Subject: FW: F/24/97312 Land adj. 4 Brookfield, Providence Hill - amended landscape information - further landscape comments

I have now had the opportunity to review the latest revised landscape plans for this project.

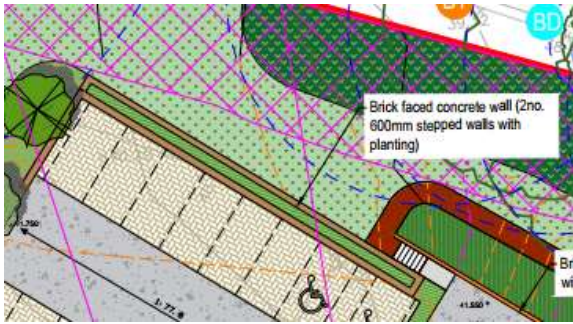
a/ I remain of the view that a gap in the boundary screening along the northern boundary in the location below should be closed. A break in the planting here will allow unfiltered views into the site from the north at lower levels.

The agent states '*...The treatment on the northern boundary is deliberately varied to allow a variety of views*', however, it is my recommendation that this gap is planted up to lessen visual impact for Goslings Turning residents.
